In the matter of Plan Change 18 (Hendersons Residential Rezoning) to the
Christchurch District Plan

**Rebuttal Evidence of Bryan John
McGillan**

26 August 2026

Appendix 2 – Proposed changes to the ODP plan

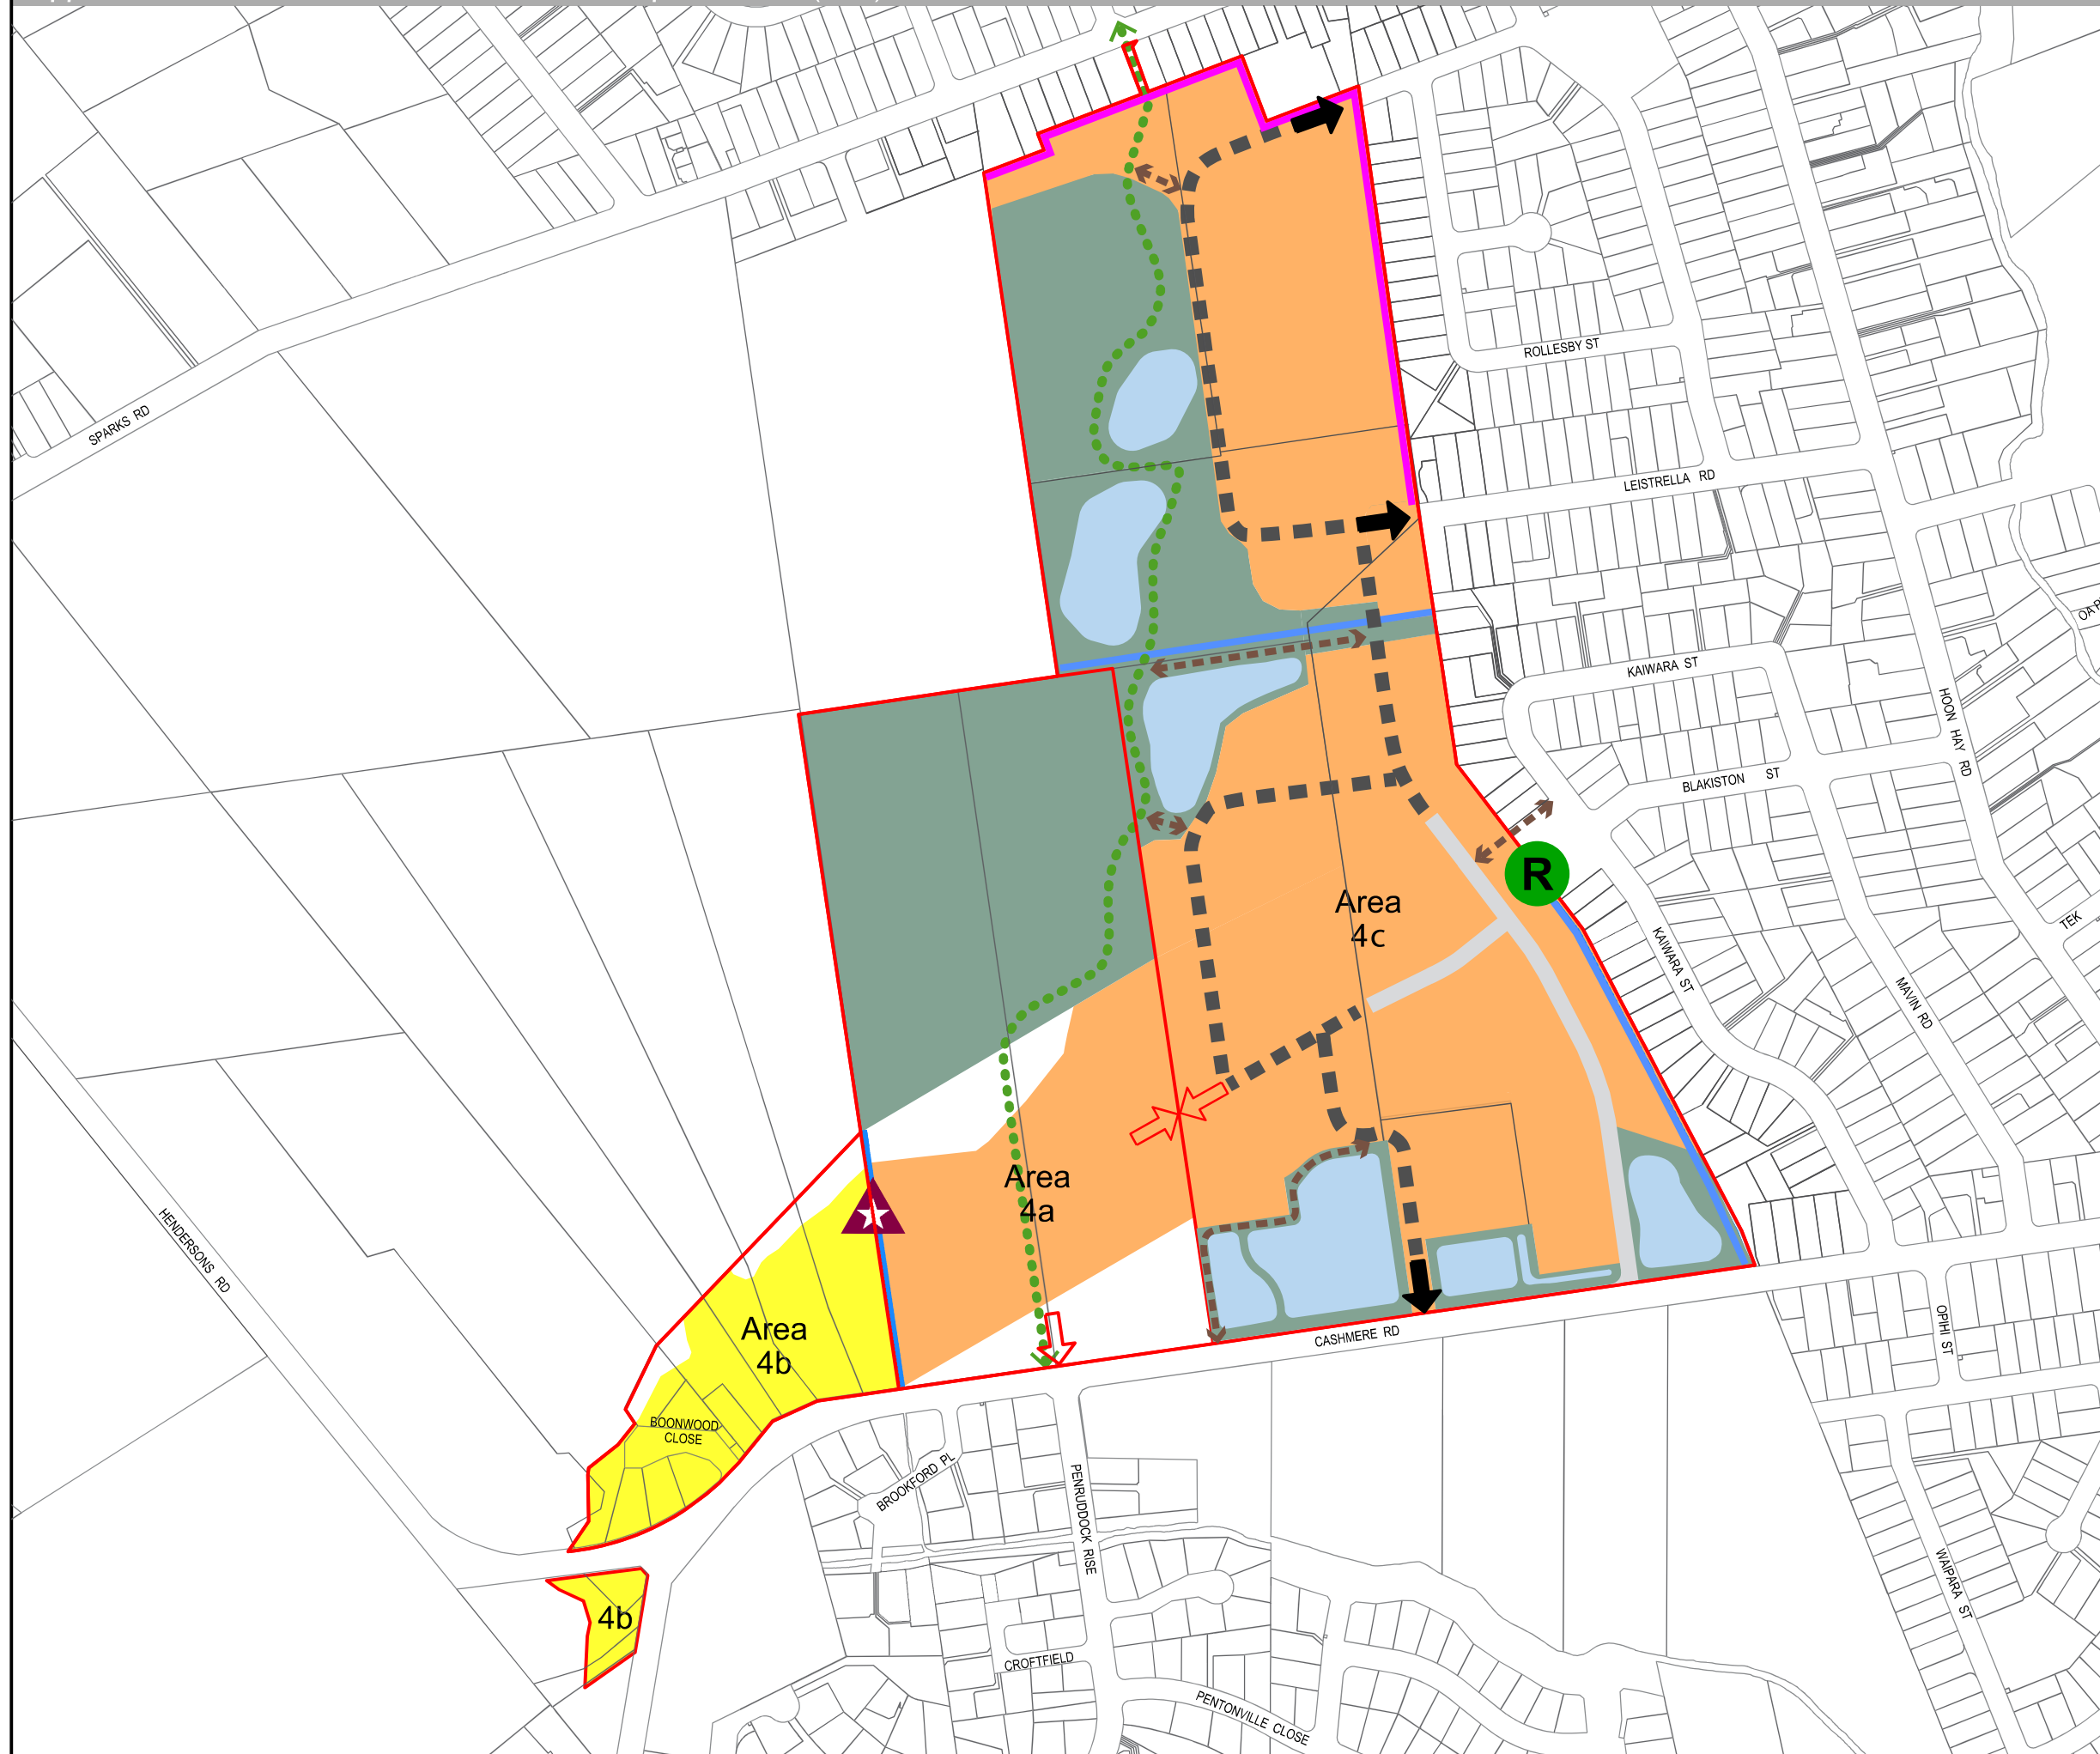
11 The ODP plan, see Appendix 2, has been updated to show:

- (a) PC18 area (Area 4c); and
- (b) 4m setback from the residential interface, described in clause 18.10.18 C (13).

- Residential development area
- Residential development area with greater development constraints
- 4m building setback along northern and eastern boundaries, north of Listrella Road
